# **Planning Board Minutes**

Wednesday, September 13, 2006

# Raymond Town Hall

Map 4, Lot 31A LRR2 Off Raymond Cape Road (FL 12) Dependable Builders Group, Inc. Daniel Franzone Sketch Plan/Pre-Application Conference for Turtle Cove Estates, a 4-lot subdivision on 29.3 acres.

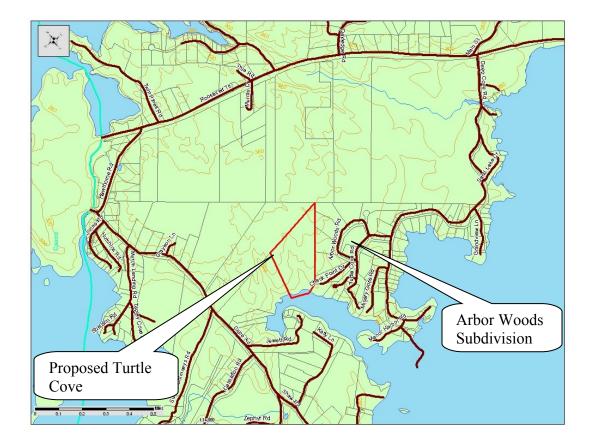
This is a pre-application sketch plan review for a 4-lot subdivision on 29.3 acres on Turtle Cove, an inlet of Sebago Lake. The property is located on Fire Road 12 off of the Raymond Cape Road and is accessed by an existing private gravel road with a 50 foot right of way. The applicant proposes to upgrade the existing road to the boundary of the property and then build a new road to serve the four lots and provide the necessary road frontage. The applicant has proposed four lots ranging in size from just over 3 acres, the minimum allowed in this zoning district, to 13 <sup>1/2</sup> acres. Two of the lots are proposed to be on the cove and each would have the required 225 feet of shoreline.

Issues the board may want to discuss include the length of the proposed dead-end road system, the ordinance requirements to reserve 10 % of the land, including shoreline, in open space, the appropriateness of the lot configurations, the road design, and whether to hold a site walk.

**Article IX, Section 3.2.5 of the Subdivision Ordinance** limits dead-end streets in subdivisions to 1,000 feet in length from its connection with an existing public street or an approved subdivision street. The applicant has proposed a street system that far exceeds the 1000 foot limitation. The existing private road which the applicant proposes to upgrade is about 1700 feet in length and the new roadway would be about 900 feet for a total dead-end road length of about 2600 feet.

*Article VIII, Section 4.1 of the Subdivision Ordinance* requires that subdivisions reserve a minimum of ten percent of the gross area of the subdivision as open space. *Article VIII, Section 4.6* requires that, for subdivisions located on a lake, a portion of the waterfront area must be included in the reserved land. That reserved shorefront land is required to have a minimum of 200 feet of shoreline plus ten additional feet for each unit/lot. Here the open space land would be required to have a total of 240 feet of shoreline.

The applicant's land has 458 feet of shoreline, and waterfront lots are required to have 225 feet of shoreline. It does not appear that there is enough shoreline frontage for even one waterfront lot and to still meet the open space requirements of the ordinance.

*Article VIII, Section 10 of the Subdivision Ordinance* requires that the lot layout should not result in odd shaped lots or length to width ratios of greater than 3:1. Lot 2 should be examined with these provisions in mind.

Article IX, Section 3.2.2 of the Subdivision Ordinance states that all streets in the subdivision shall be designed so that, in the opinion of the Board, they shall provide safe vehicular travel. The street design standards in Section 5.5 of the Street Ordinance require a minimum angle of street intersection of 75 degrees or greater and encourages the intersection to be as close to 90 degrees as possible. Neither intersection of the proposed new subdivision road is 90 degrees but the second intersection appears

it may be less than 75 degrees. The road design should be reviewed with these ordinance provisions in mind.

- more contour mapping
- a design with a shorter road lay out
- site walk before hunting season begins
